Product Change Notice (PCN)

PCN Number: PCN-080312_01

Product(s) Affected: PJ-019

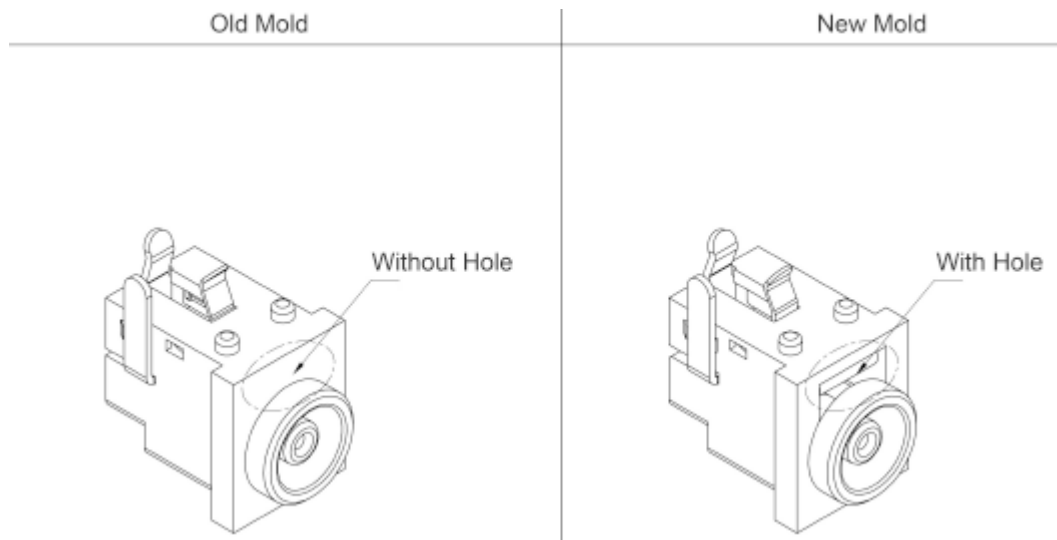
Reason(s) for Change: The mold for the plastic injection reach was discontinued.

Description of Change: There is now a small hole in the front of the jack.
